Docket No. 12-BSTD-01
2013 Title 24 Building Energy Efficiency

Robert B. Weisenmiller, PhD
Commissioner, California Energy Commission
Dockets Office, MS-4
Re: Docket No. 12-BSTD-1
Adoption of 15-Day Language for the 2013 Energy Efficiency Building Standards
1516 Ninth Street
Sacramento, CA 95814-5512
docket@energy.ca.gov [Via email]

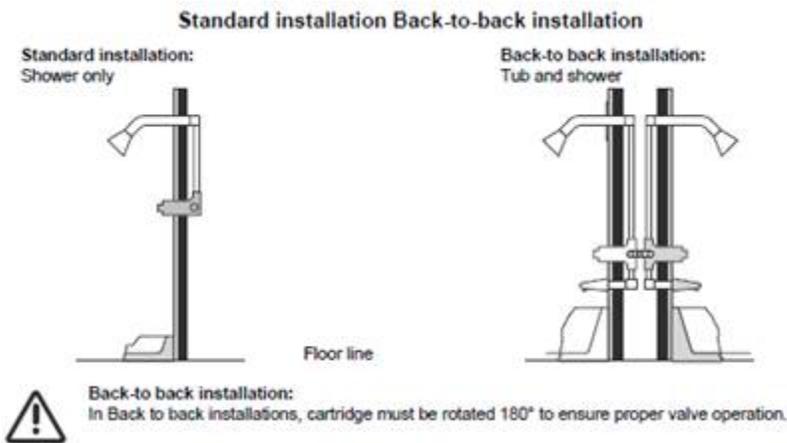
5. The technical accuracy of the added language in Title 24 Part 6, Section 110.3 is also problematic. There continues to be unresolved issues that we see in the added process in Title 24 Part 6 and errors in the technical merits of this effort of adding duplicate language to the water heater section:

a) This proposal disregards back-to-back showers:
